SERVICE INFORMATION

NUMBER: 02-162-15
DATE: 09/10/15

SUBJECT: Change to Engine Oil Pressure Switch

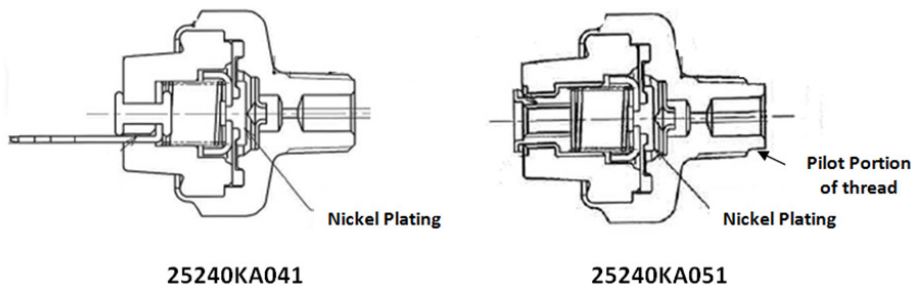
This Service Information bulletin announces a design change to the oil pressure switch assembly. Nickel plating has been applied to the internal switch contacts to enhance their durability and reduce the possibility of poor contact which could affect operation or cause improper illumination of the oil pressure warning lamp. A small pilot portion was added to the threaded area on p.n. 25240KA051 as shown in the illustration below.

NOTE: The oil pressure switches shown below supersede part numbers 25240KA040 and 25240KA050 respectively.
